SUBMITTAL COVERSHEET **Nanuet UFSD –Phase 3 Projects**

Product Name: STRUCTURAL STEEL FOR MIDDLE SCHOOL AS BUILTS AND HP-MS LOCATIONS

JOB Barr Middle School
Roof reinforcements

TITLE **ROOF REINFORCEMENTS**

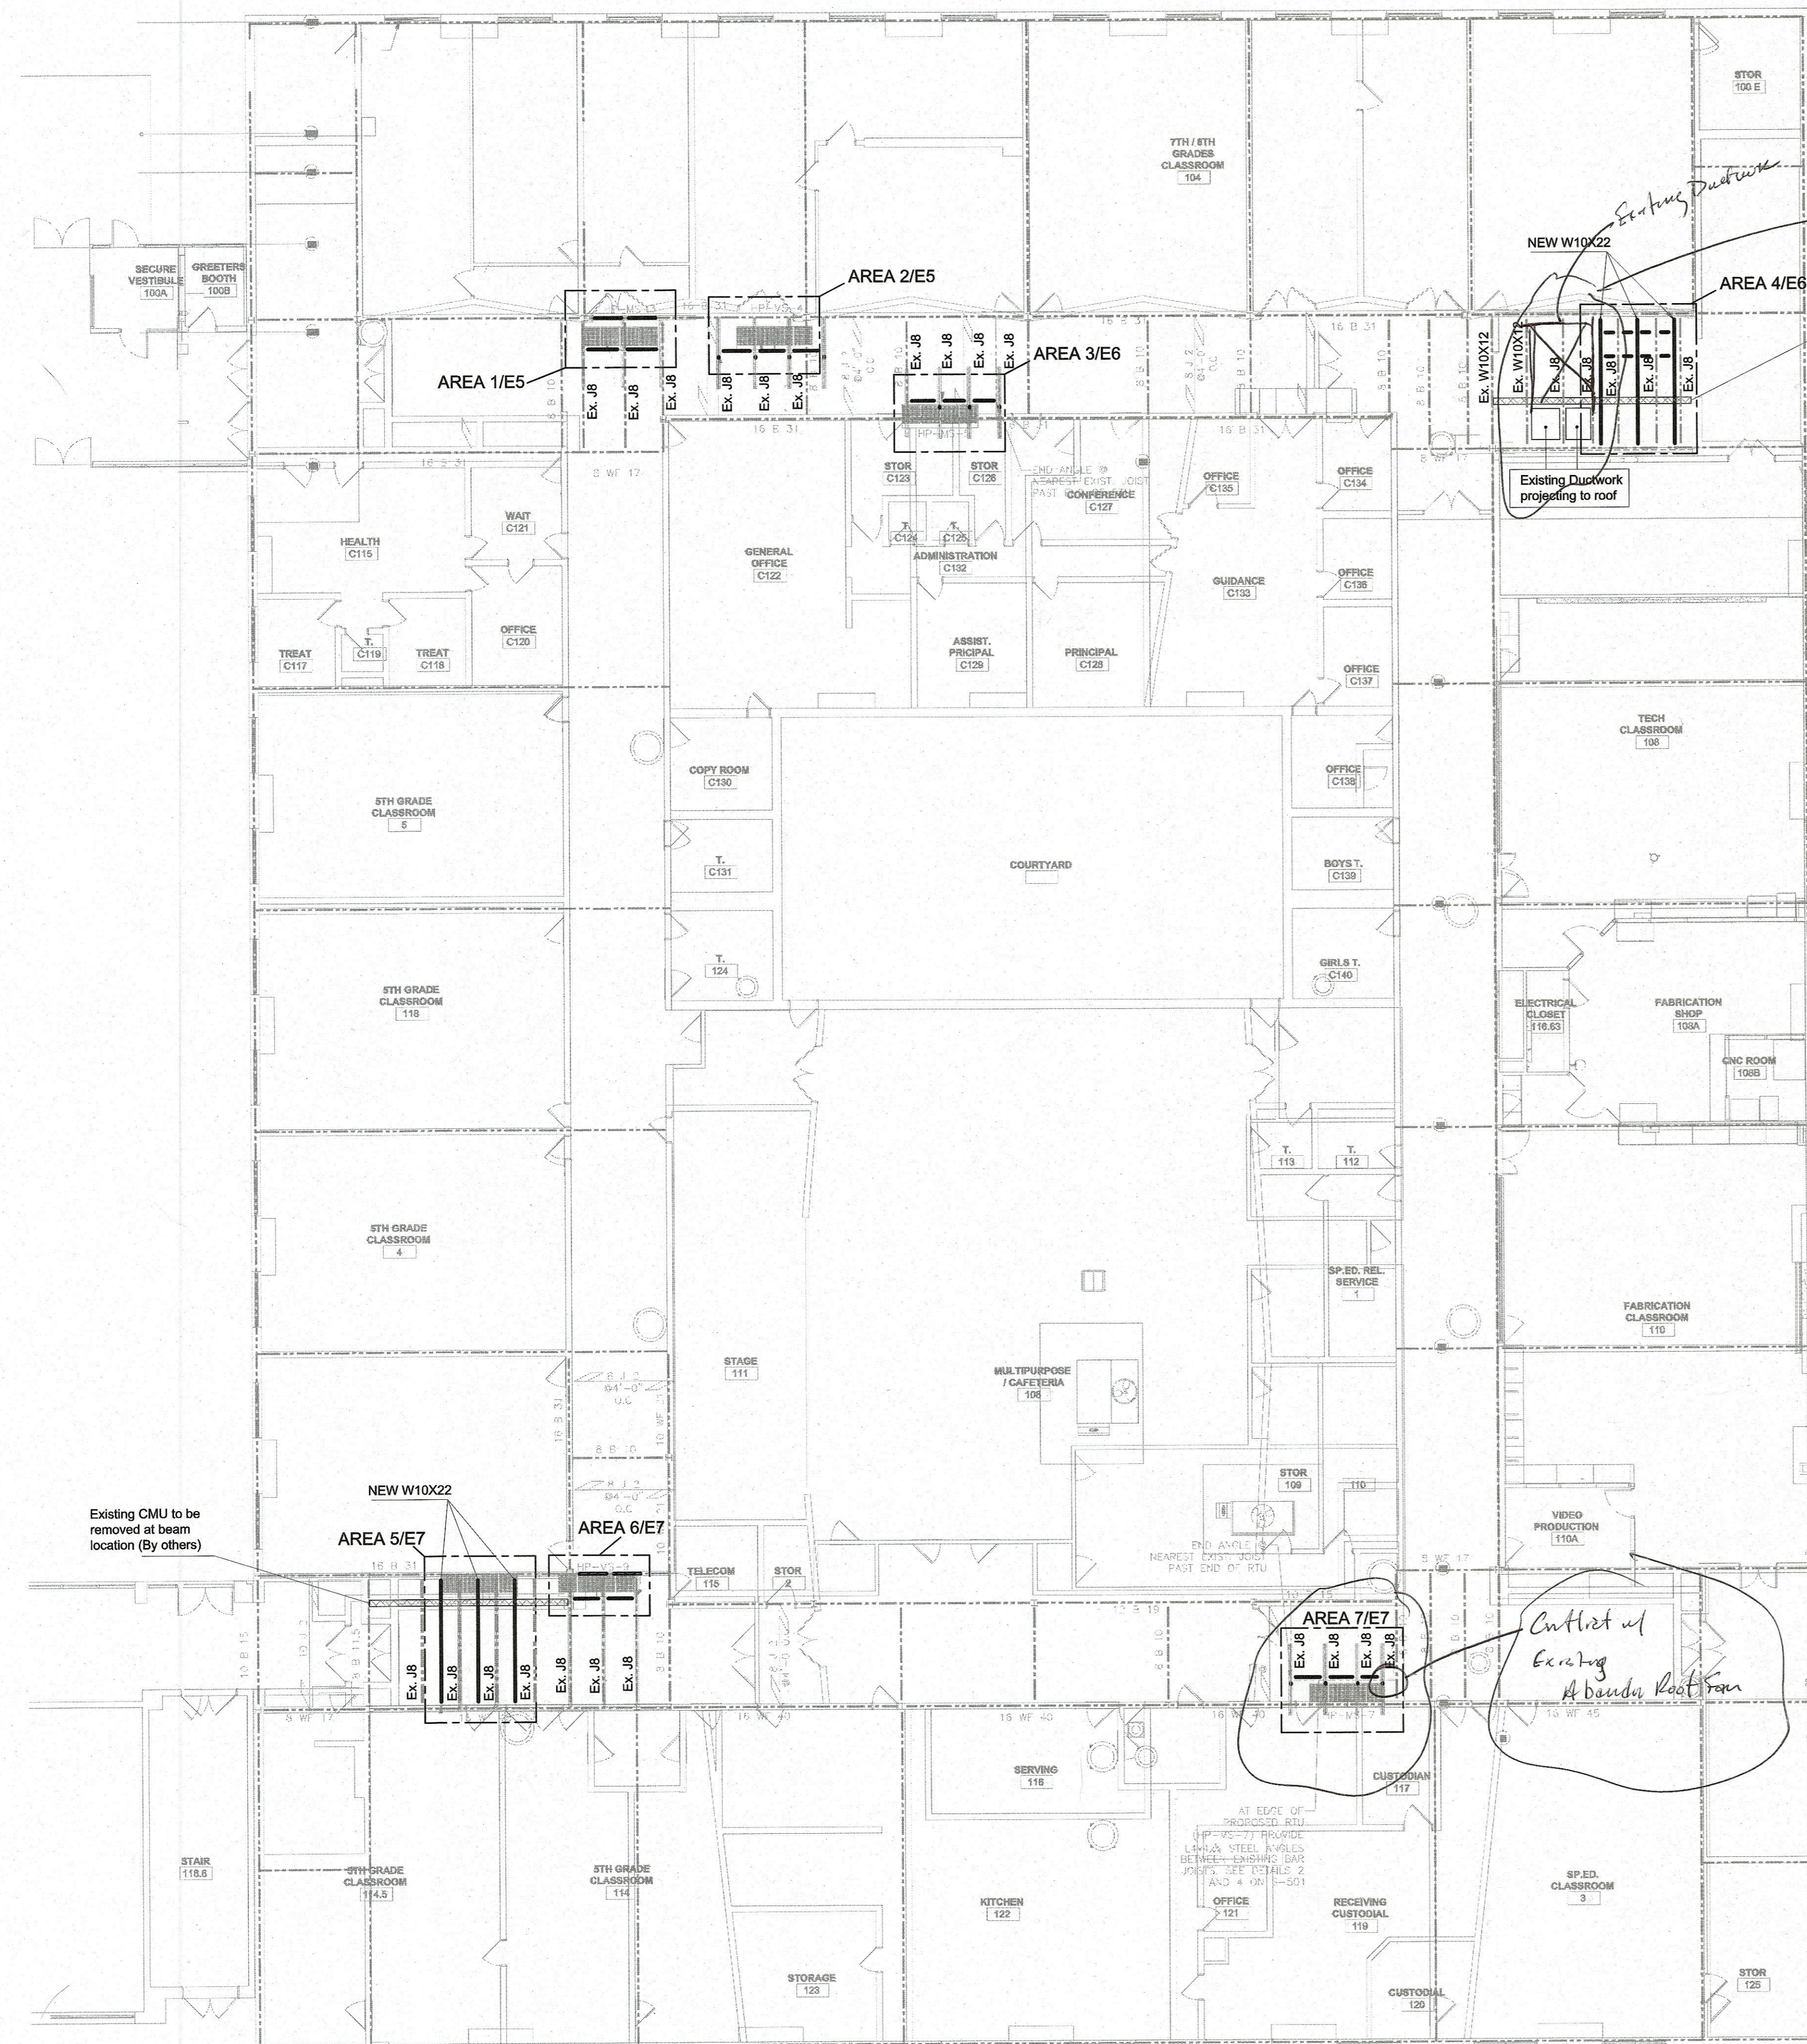
There is no structural nor mechanical issues with shifting the unit at the top of the page to the right.

For the unit at the bottom of the page please see sheet BM-M109 for rooftop fans to be removed.

- Potential Conflict w/ Ductwork on Roof
- were going to slide Units to right on Rails

Conflict w/ a Old Existing Fan
Then Fan is Abandon
Rafter needs to Remove
on d Patch Deck

Reviewed and approved by structural.
